Access Compliance Report Public Rights-of-Way (Pedestrian Signals)

Main Street: DANA_POINT_HARBOR_DR Cross Street: STREET_OF_THE_GOLDEN_LANTERN Location: NE

ADA ID: SGRK220208164604 Signal Type: One Push Button-Non APS Overall Compliance: No Severity Scores: BTN 1: 55 BTN 2: N/A No BTN: N/A

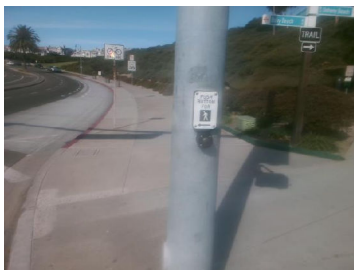
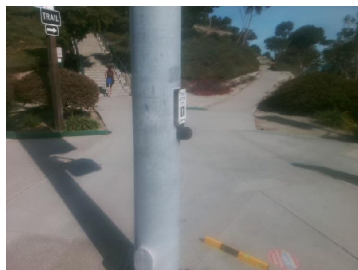
N/A B 1 FWD Approach Obstruction?	N/A	N/A	B 2 FWD Approach Obstruction?	N/A	
N/A B 1 FWD Approach Obstruction Dist (in)	N/A	N/A	B 2 FWD Approach ObstructionDist (in)	N/A	
N/A B 1 PARA Approach?	N/A	N/A	B 2 PARA Approach?	N/A	
N/A B 1 PARA Approach Constrained?	No	N/A	B 2 PARA Approach Constrained?	N/A	
Yes B 1 PARA Approach Reach (in)	2	N/A	B 2 PARA Approach Reach (in)	N/A	
N/A B 1 PARA Approach Width (in)	N/A	N/A	B 2 PARA Approach Width (in)	N/A	
N/A B 1 PARA Approach Obstruction?	Yes	N/A	B 2 PARA Approach Obstruction?	N/A	
N/A B 1 PARA Approach Obstruction Dist (in)	2	N/A	B 2 PARA Approach Obstruction Dist (in)	N/A	
No B 1 Clear Floor Space Slope (%)	9	N/A	B 2 Clear Floor Space Slope (%)	N/A	
No B 1 Clear Floor Space XSlope (%)	2.2	N/A	B 2 Clear Floor Space XSlope (%)	N/A	
N/A B 1 PAR Slope (%)	4.8	N/A	B 2 PAR Slope (%)	N/A	
No B 1 Height (in)	49	N/A	B 2 Height (in)	N/A	
Yes B 1 Pressure (#)	2	N/A	B 2 Pressure (#)	N/A

Possible Solutions: Replace Signal Push Button With APS Button. Adjust Signal Button Height. Remove and Replace Clear Space.

OC Std/PROW: R404.2, R404.3, R406, MUTCD 4e.08
